UNITED STATES PATENT AND TRADEMARK OFFICE

APPLICATION NO.	FILING DATE	FIRST NAMED INVENTOR	ATTORNEY DOCKET NO.	CONFIRMATION NO.
10/028,242	12/20/2001	Brian Christian Orr	V201-0077	2148

Office Action Summary

DETAILED ACTION

EXHIBIT 1

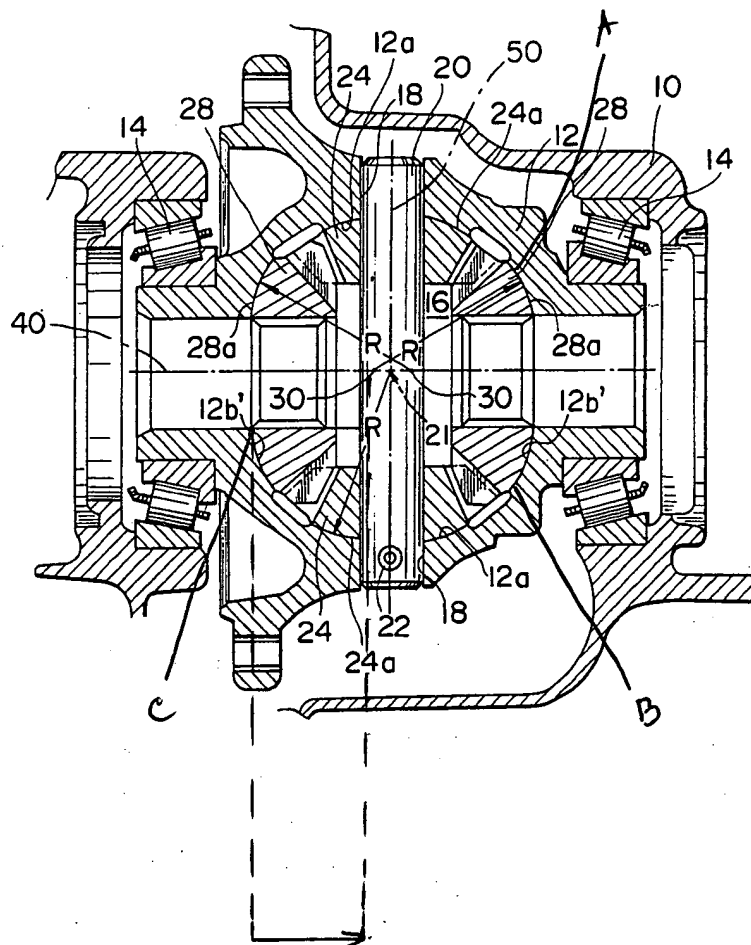
Regarding claim 1, Hokusho et al'306 shows a differential casing (see Fig. 2) comprising a chamber (16) having an axle centerline (40), a centerpoint (21), and defined by at least one spherical surface (A) (see Exhibit 1) and at least one opposing surface (B) (see Exhibit 1), wherein a centerpoint (30) of said at least one spherical surface (A) is substantially collinear with said axle centerline (40) and is offset from the centerpoint (21) of said chamber by an offset distance along said axle centerline in a direction away from said opposing surface (B).

Regarding claim 3, Hokusho et al'306 shows an automotive differential mechanism (see Fig. 2) comprising a first side gear (right 28) having a spherical centerpoint (30); a second side gear (left 28) having a surface (C) (see Exhibit 1); and a differential chamber (16) formed by offsetting the spherical centerpoint (30) of said first side gear away from the surface of said second side gear (see Exhibit 1).

Regarding claim 4, Hokusho et al'306 shows an automotive differential mechanism (see Fig. 2) comprising a pinion shaft (20); first and second pinion gears (24); a first side gear (right 28) having a first side gear outer radius (R); a second side gear (left 28) having a second side gear outer radius (R); and a differential casing having an axle centerline (40), a casing centerpoint (21), a first axle shaft port (right 12b'), a second axle shaft port (left 12b'), a first inner radius (i.e., the radius coincides with the radius R of the right side gear 28), a first radius center point (left 30), a second inner radius (i.e., the radius coincides with the radius R of the left

side gear 28) and a second radius center point (right 30), wherein said second radius center point (right 30) is substantially collinear with said axle centerline 940) and offset from said casing centerpoint (21) an offset distance along said axle centerline in a direction away from said first inner radius (i.e., the radius coincides with the radius R of the right side gear 28). Regarding claim 5, wherein said first and second side gears (28) do not have alignment shoulders.

14. Claim 2 is rejected under 35 U.S.C. 103(a) as being unpatentable over Hokuscho et al. (US 4,541,306). Hokuscho et al'306 shows the radius (R) of said at least one spherical surface (A) much larger than the offset distance between the centerpoint and the centerpoint (30) of the at least one spherical surface (A). Hokuscho et al'306 leaves it up to one having ordinary skill in the art to come up with a ratio of the radius of the at least one spherical surface to the offset distance. It would have been obvious to one of ordinary skill in the art at the time the invention was made to select the ratio of the radius of the at least one spherical surface to the offset distance be at, since such a selection would have involved a mere change in the size of a component, e.g., how large the differential chamber is. A change in size is generally recognized as being within the level of ordinary skill in the art. In re Rose, 105 USPQ 237 (CCPA 1955).
